YARRA CITY COUNCIL

Internal Development Approvals Committee

1.1 PLN18/0873 - 571-573 Victoria Street, Abbotsford - Use of the land for a Restricted Recreation Facility (Gymnasium) and the display of business identification signage

1. This report provides Council with an assessment of planning application PLN18/0873 at 571-573 Victoria Street, Abbotsford for the use of the land for a Restricted Recreation Facility (gymnasium) and the display of signage; and recommends approval subject to conditions

Figure 3: Proposed signage on the Victoria Street façade.

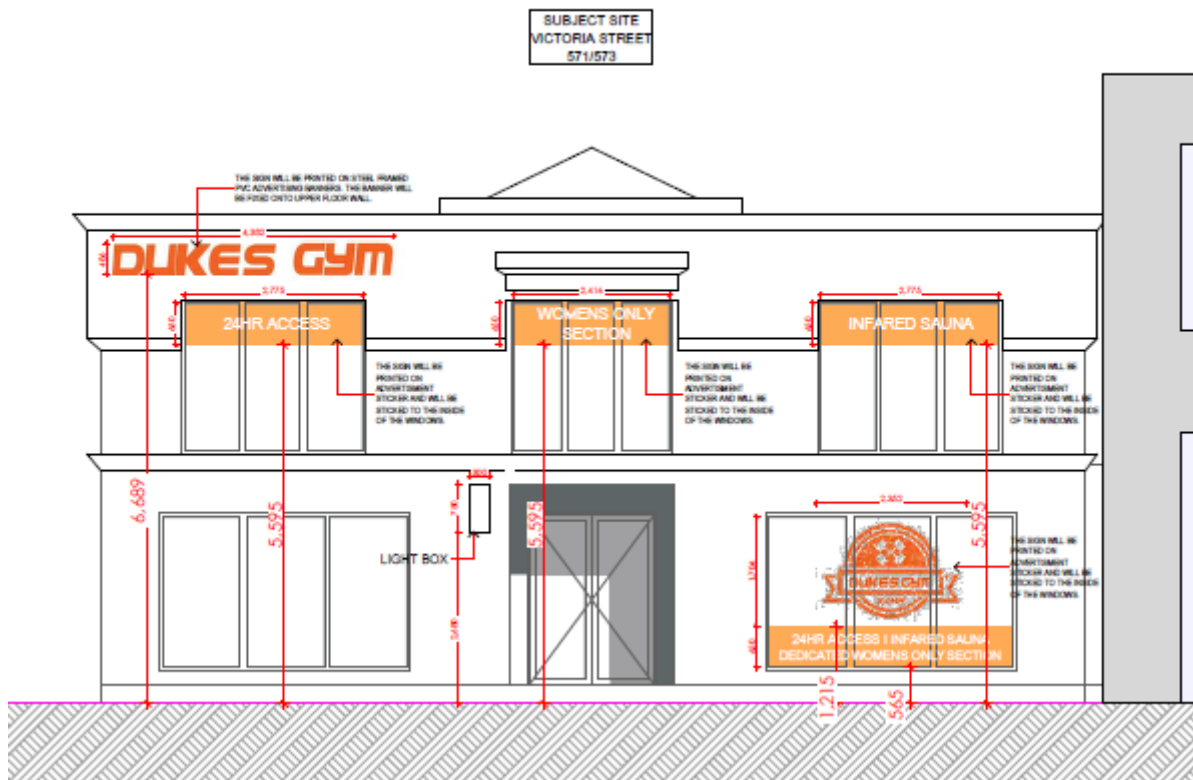
71. The application proposes to display a total of eight (8) signs along the Victoria Street and Duke Street frontages, as shown at figures 3 and 4 below.

78. The advertising signs identify the business and provide relevant information about facility. The design and function of the signage is reflective of the commercial business (24 hour gym) that operates on site.

- (d) An annotation confirming a minimum 750mm distance of the internally illuminated sign to the edge of the kerb.
- 2. The use, and the location and details of signage as shown on the endorsed plans must not be altered (unless the Yarra Planning Scheme specifies that a permit is not required) without the prior written consent of the Responsible Authority.

GROUND FLOOR PLAN 1:100

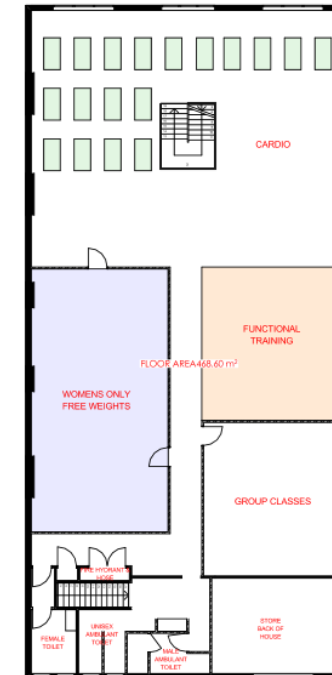
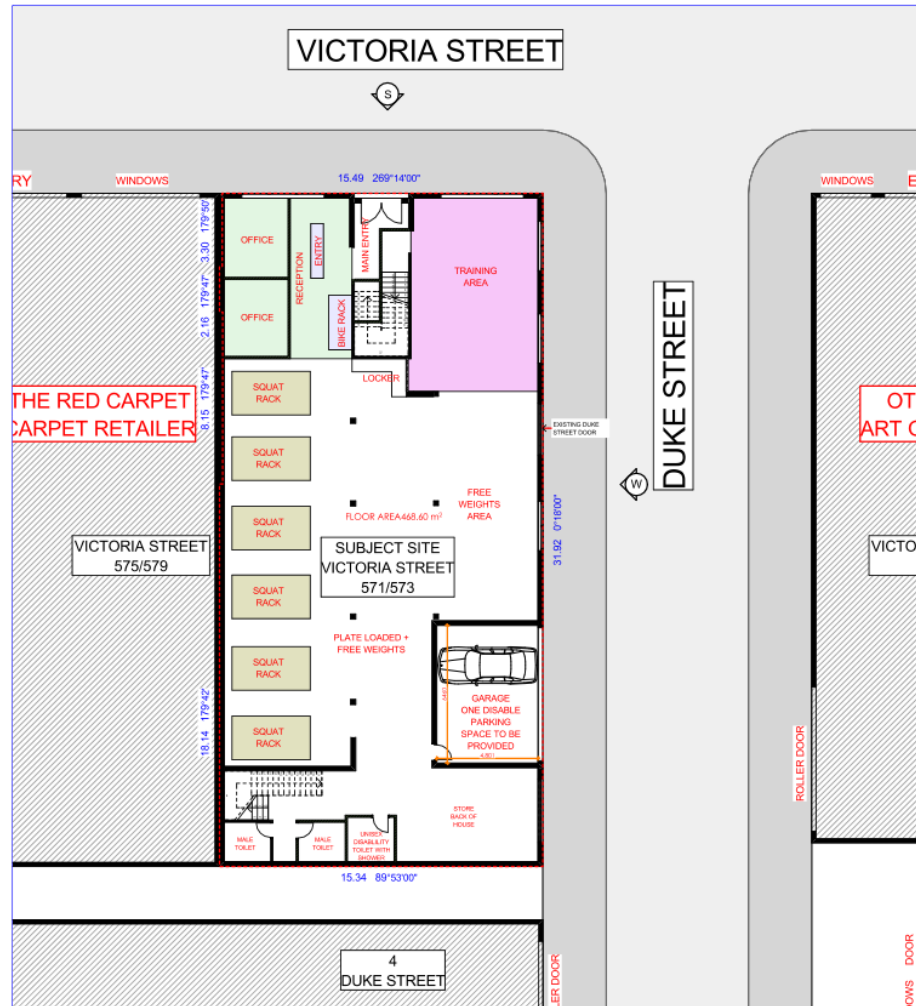
87. Whilst the decision plans show an area set aside internally for bicycle parking the number of spaces is not noted on the plans. The application package confirms that six (6) spaces are proposed. As such a permit condition is recommended for the number of bicycle spaces to be annotated on the plans, should a permit issue.

* Garage to accommodate one accessible parking space – CS Town Planning Services Drawing No. TP05 dated 31 January 2019

1. Before the use commences or signage is displayed, amended plans to the satisfaction of the Responsible Authority must be submitted to and approved by the Responsible Authority. When approved, the plans will be endorsed and will then form part of this permit. The plans must be drawn to scale with dimensions, and three copies must be provided. The plans must be generally in accordance with the decision plans but modified to show:
 - (a) Deletion of reference to the disabled parking spot;
 - (b) An annotation confirming 6 bicycles spaces will be located within the internal bicycle storage area;
 - (c) The bin storage location concealed from the public realm;
